APPLICATION FOR SOIL INVESTIGATION

APPENDIX II
SITE EVALUATION

SITE INVESTIGATION REPORT
INDIVIDUAL SEPTIC TANK SYSTEM
WITH SUBSURFACE,
SOIL ABSORPTION,
EFFLUENT DISCHARGE

S.I.R. No. 16662

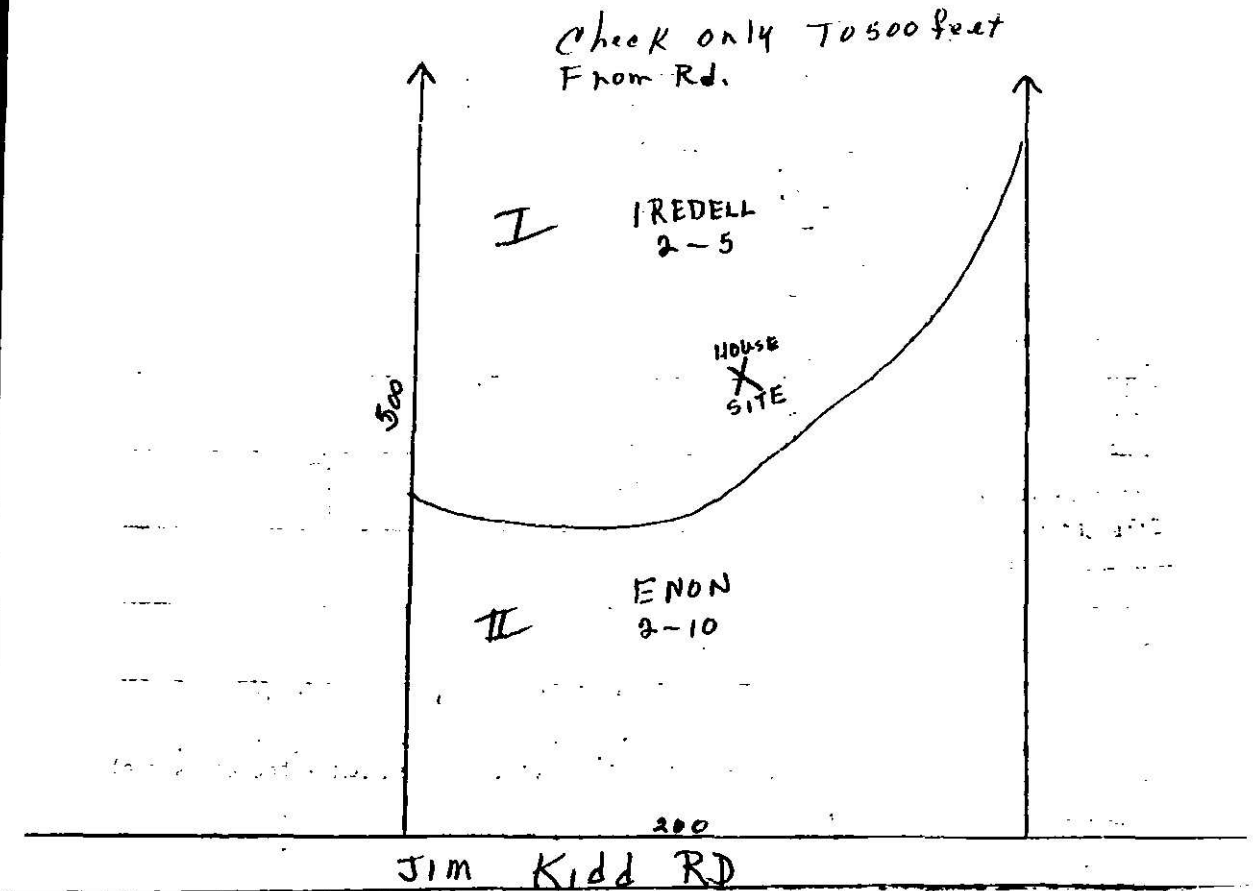
FACTORS	AREA 1	AREA 2	AREA 3	AREA 4
1. SLOPE (%)	S (PS) 2-5 U	S (PS) 2-10 U	S PS U	S PS U
2. SOIL TEXTURE (12-36 inches) Sandy, Loamy, Clayey (Note 2:1 Clay)	S PS (U) 2-1 Clay	S mostly PS (U) 2-1 Clay	S PS U	S PS U
3. SOIL STRUCTURE (12-36 inches)	S PS (U) massive	S PS (U) Massive	S PS U	S PS U
4. SOIL DEPTH (inches)	S PS (U) 48	S PS (U) 48	S PS U	S PS U
5. RESTRICTIVE HORIZONS (inches) (Impervious strata, Rock)	S PS (U) Clays	S PS (U) Clays	S PS U	S PS U
6. SOIL DRAINAGE/GROUNDWATER (external and internal)	S PS (U) slow	S PS (U) slow	S PS U	S PS U
7. SOIL PERMEABILITY (percolation rate)	S (PS) slow U	S PS (U) slow	S PS U	S PS U
8. OTHER (specify)	S PS U	S PS U	S PS U	S PS U
9. SITE CLASSIFICATION	✓ Unsuitable	Unsuitable		
10. SOIL SERIES	Iredell	ENON

** See Diagram on Back (includes: soil areas, property lines, roads, streams, gullies, wet areas, fill areas, wells, water bodies, slope)

Recommendations/Comments: I Would RATE This LOT VERY Severe.
